PLANNING RESPONSES
SUNLIGHT HOUSE
APRIL 2023

EXTERNAL ALTERATIONS

INTERNAL ALTERATIONS

1. EXTERNAL LOUVRE TO QUAY STREET

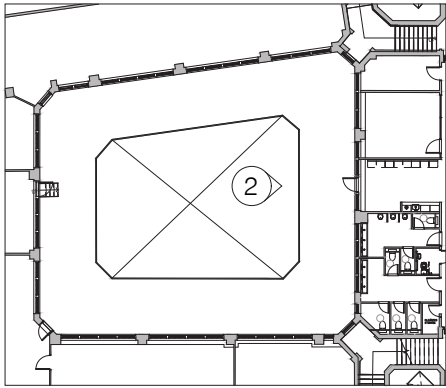
The proposed floor plans show the existing corner entrance at the junction of Quay Street/Little Quay Street retained as an active opening to the proposed cafe. However, the design and access statement shows a new glazed screen with ventilation louvre. We require clarification on this. The installation of the louvre is unacceptable. The louvres to the gym also Quay are removed which help improve the overall appearance of this elevation. We should not be introducing new louvre here. Alternative ventilation solutions should be sought. I would also like you to explore removing the existing louvres to Atkinson Street.

Agreed to remove from this application and to form an approach with the wider ground and lower ground application.

2. COURTYARD ACCESS DOOR

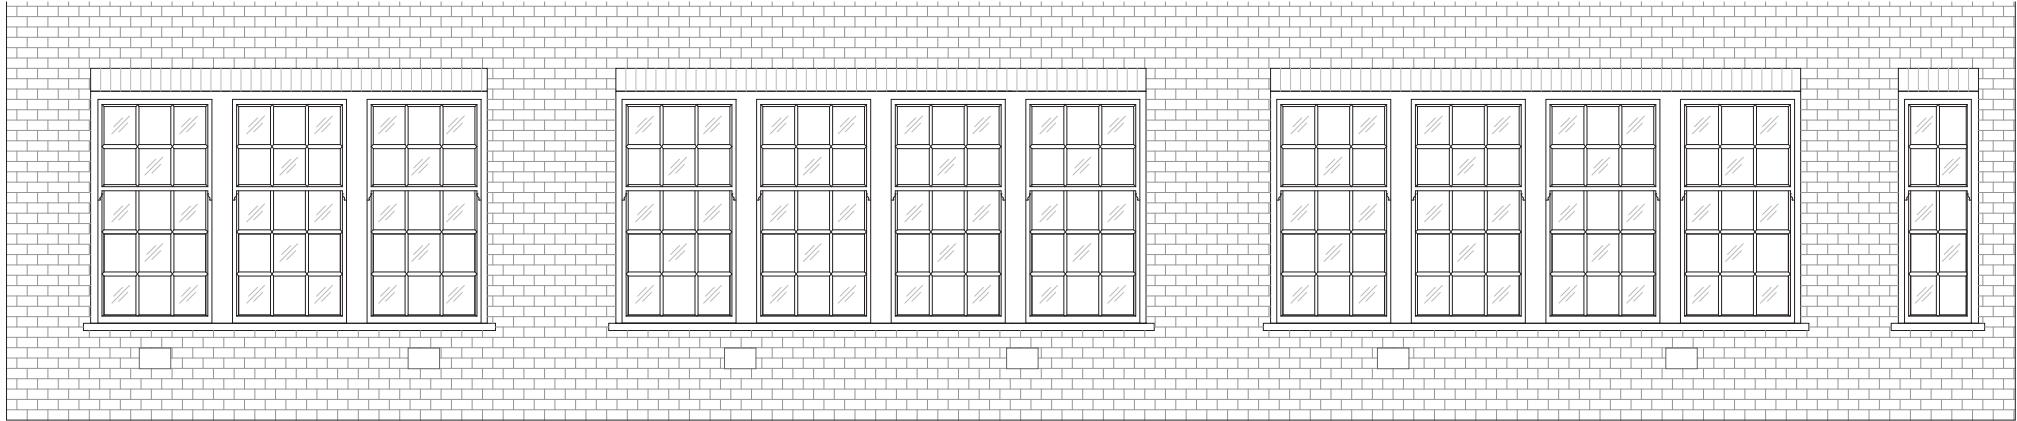
A new door appears to be being installed in the lightwell at level 1. No existing and proposed courtyard elevations have been provided. These need to be submitted. The doorway should be central.

Drawing now produced. The doorway will be integrated into the window set rather than previously approved 'modern' doors as part of the new lift application. It will appear central from internal due to wall placement.

Design intent for new atrium door. To fit in existing opening from one external window to the atrium. Door mullions to match window mullion heights. Door to match style and finish to existing windows.

3. COURTYARD DETAILS

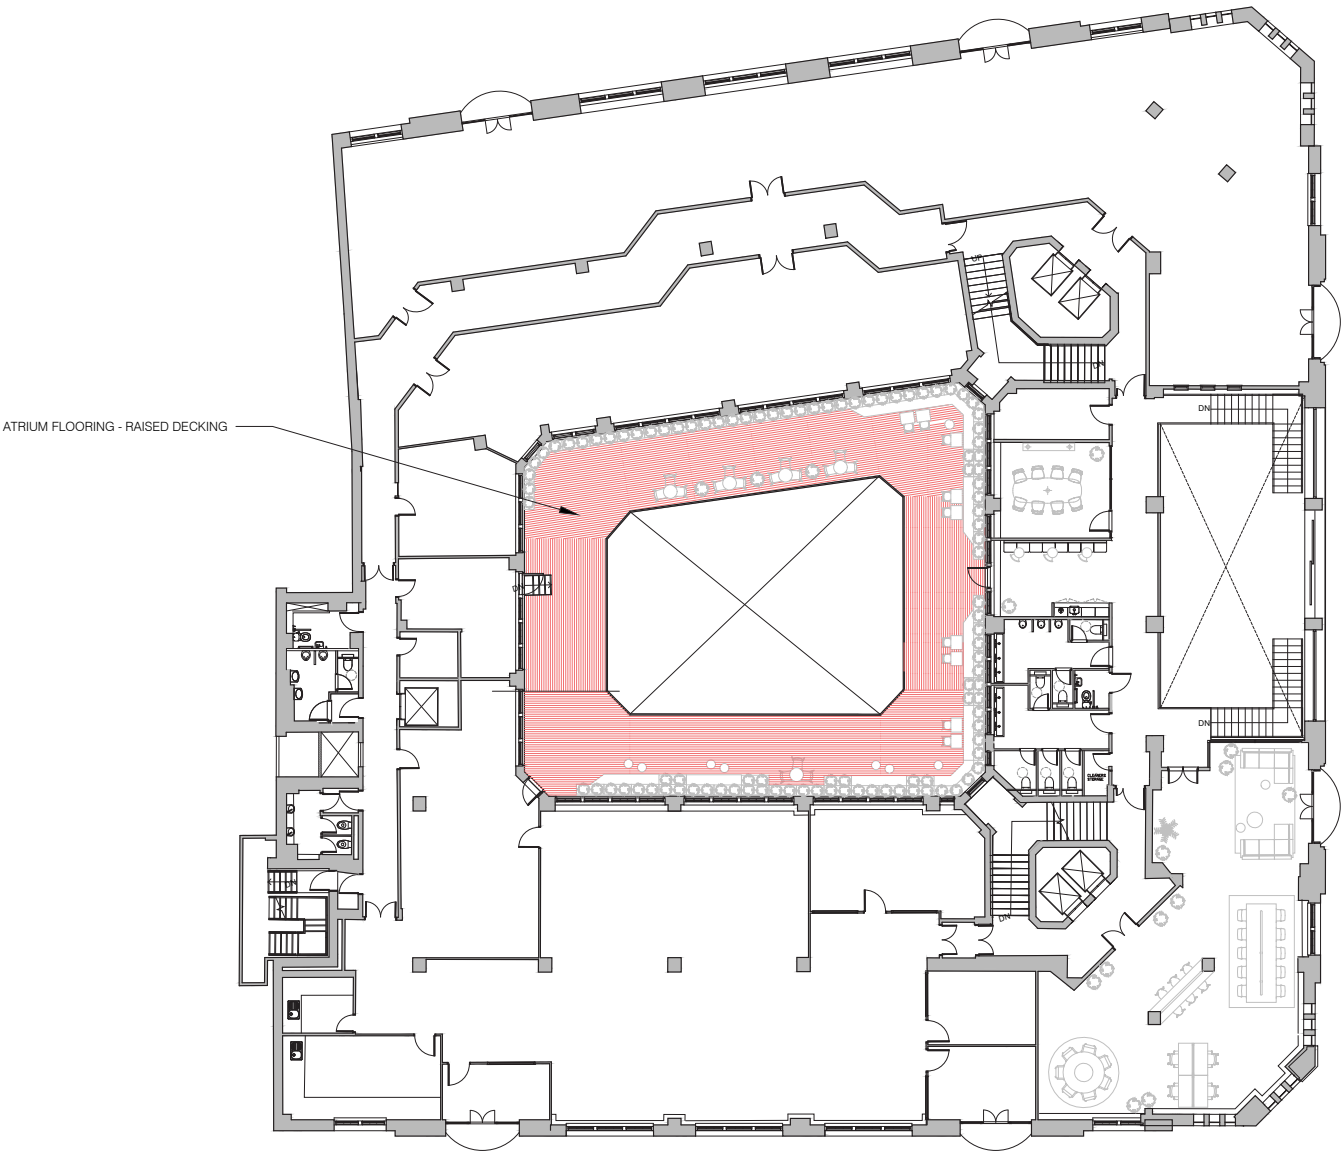
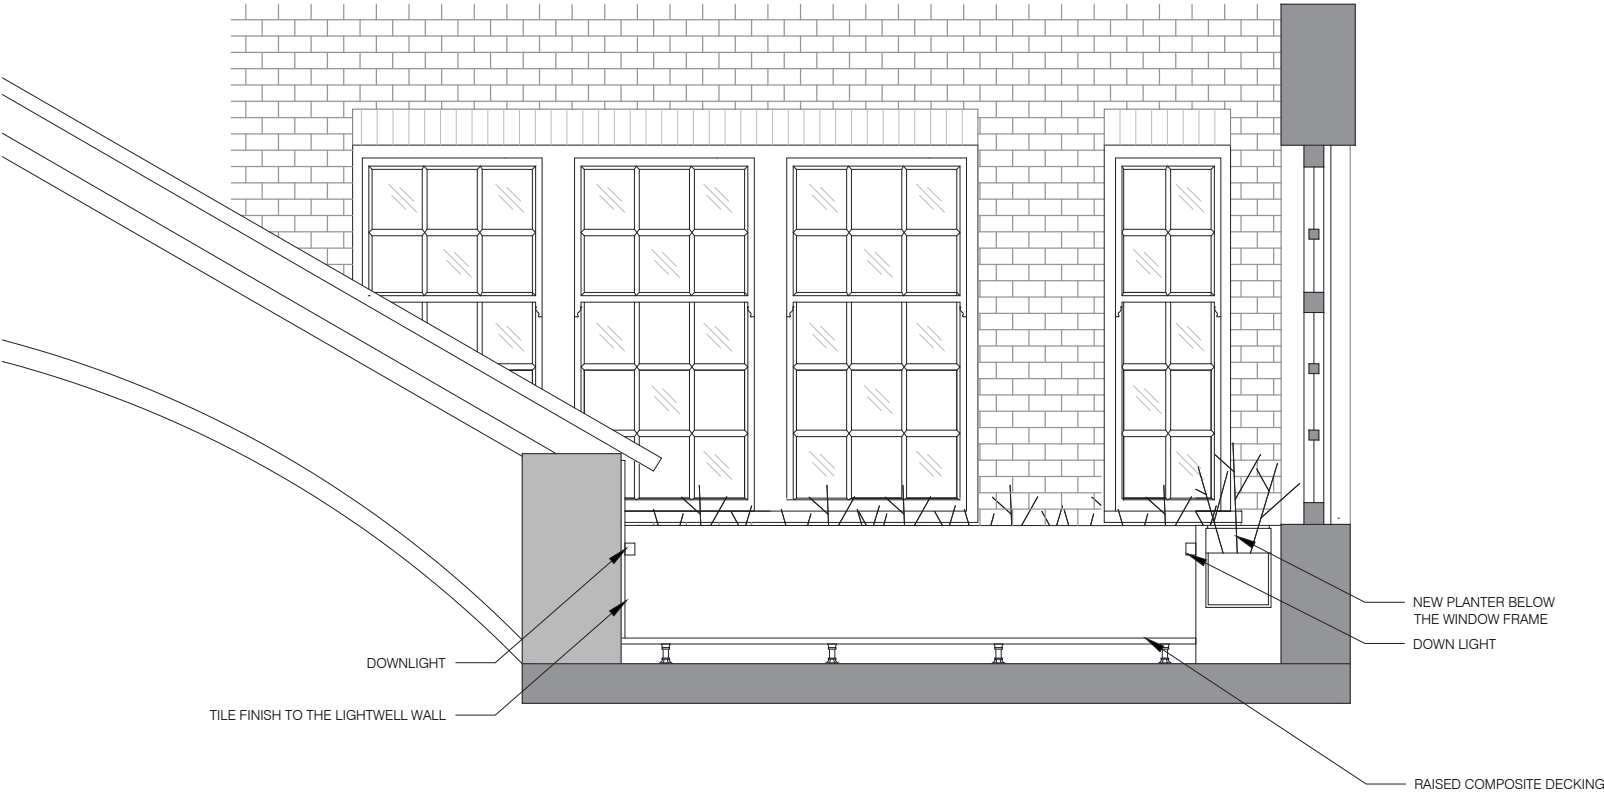
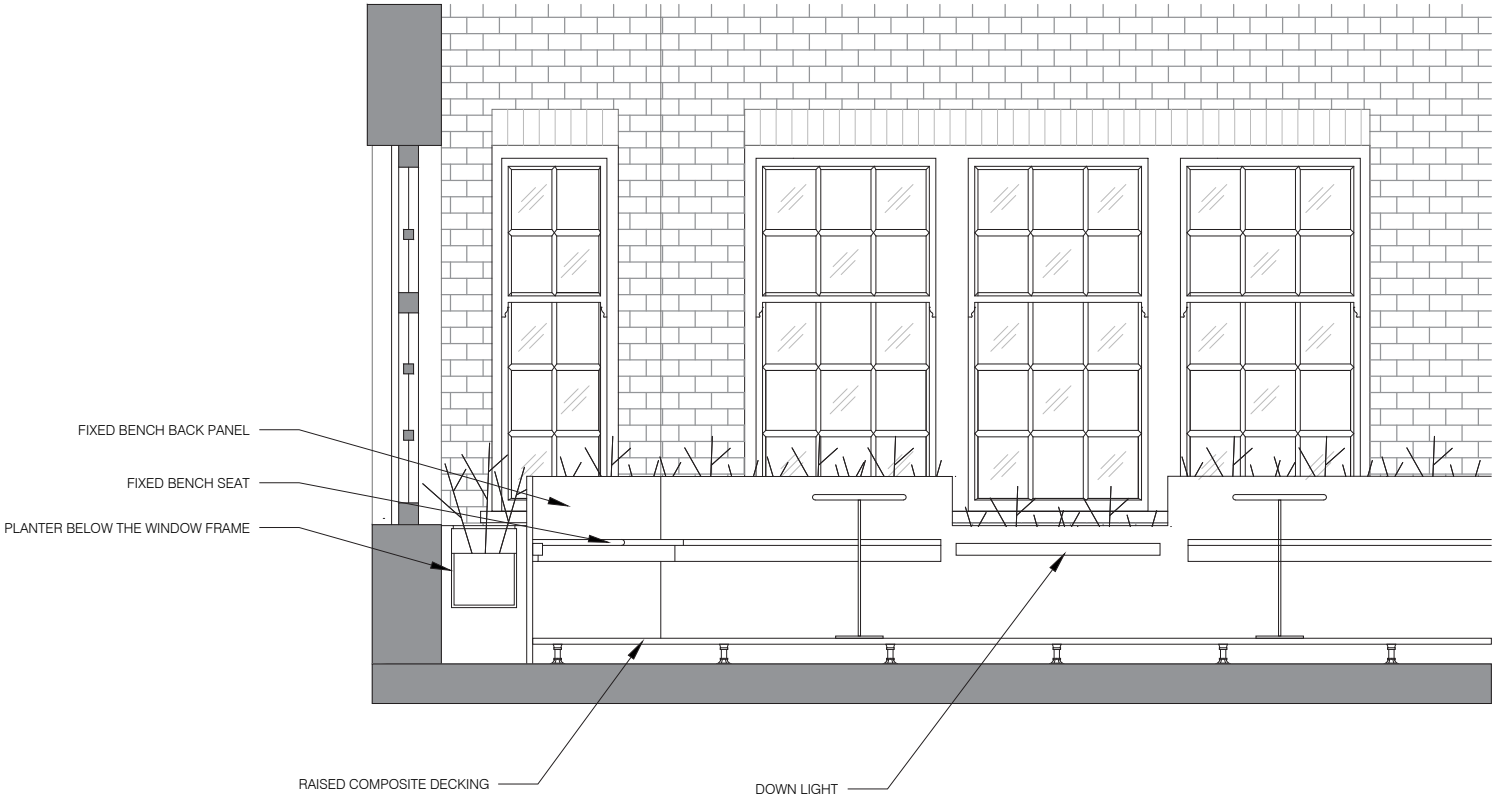
Details of the landscaping, lighting, floor finishes and any fixtures and fixing to the courtyard should be provided.

Further information provided with final materials to be approved by condition. Structural solution uses a metsec raised floor to span between existing structure and allow load sharing/better drainage/improved level access.

4. EXISTING WINDOW WORKS

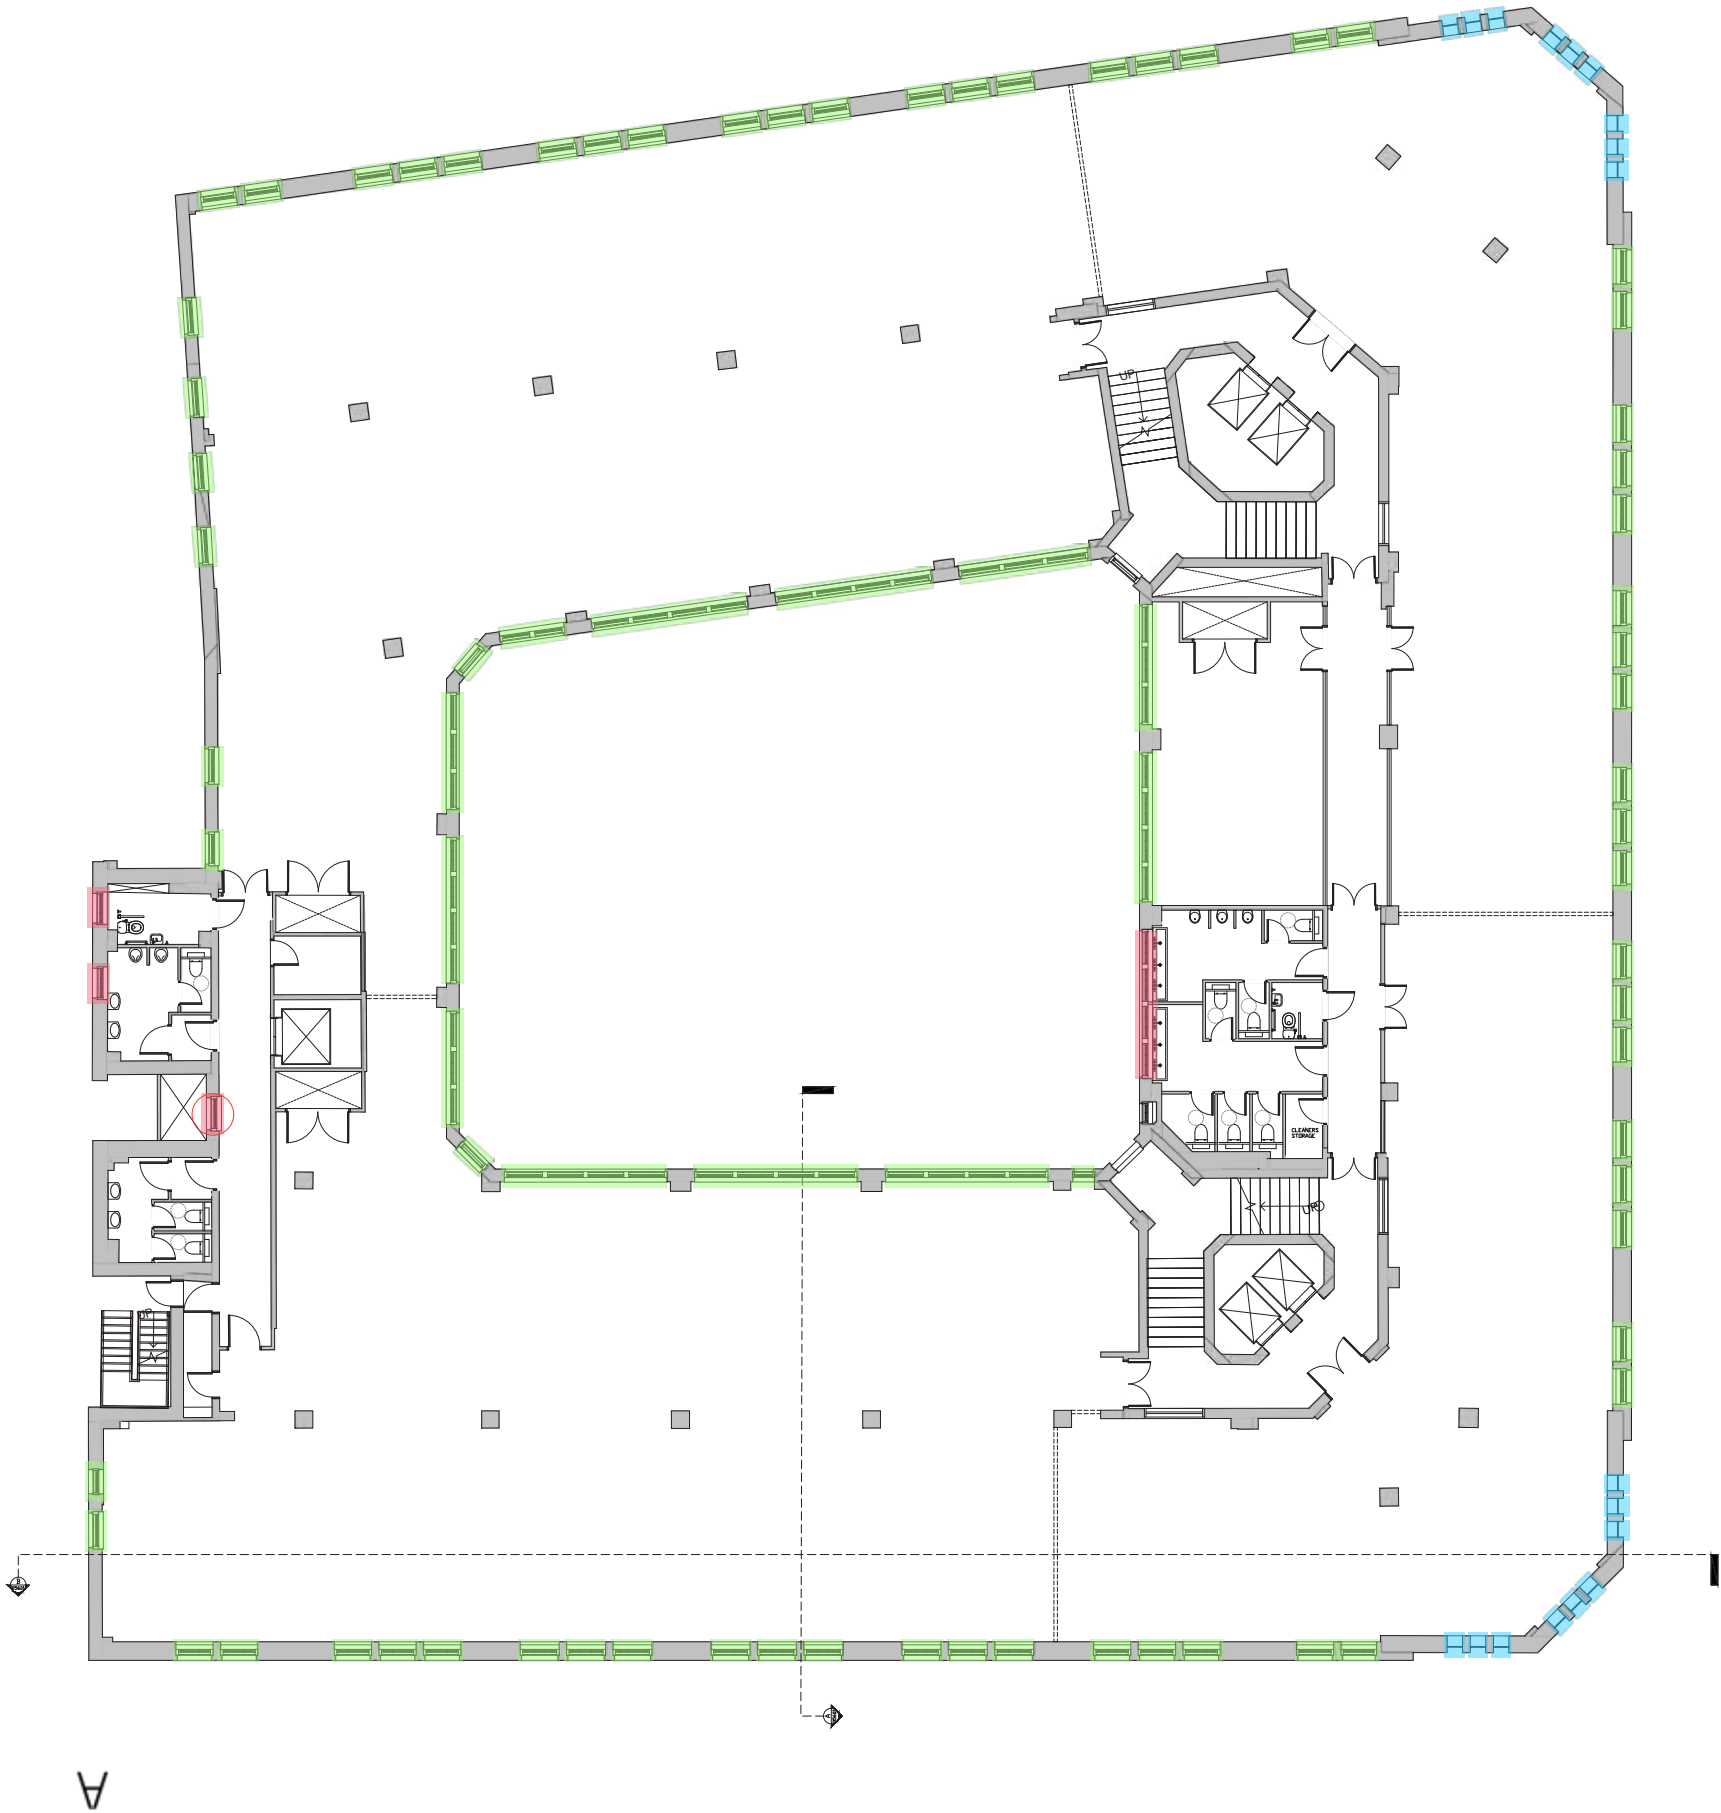
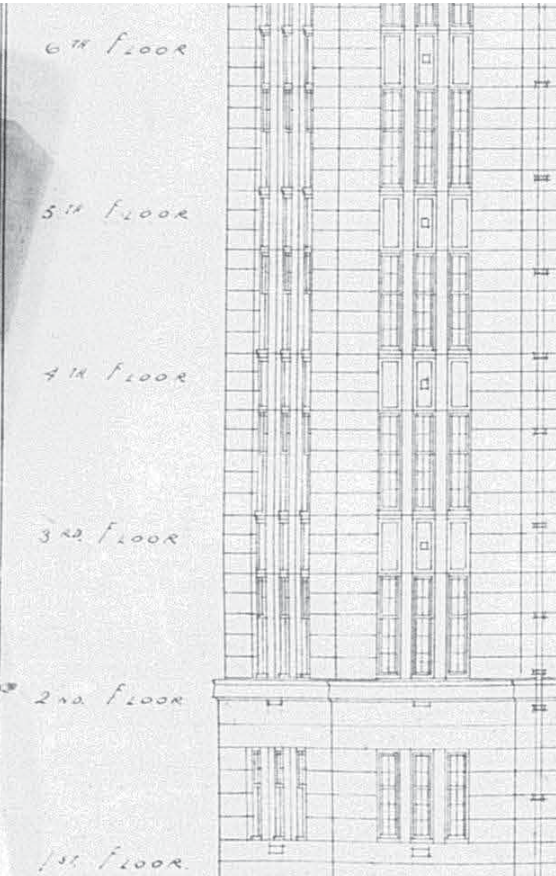
Can you clarify the works to the existing windows - the refurbished and retained windows appears to have been annotated in the same colour as refurbished and replaced windows (drawings A-21401/02/03).

Updated scoping elevations now provided. All retained windows will have an element of making good and openable works done. Primary windows to office space to have secondary glazing and core/WC windows to be made good and painted.
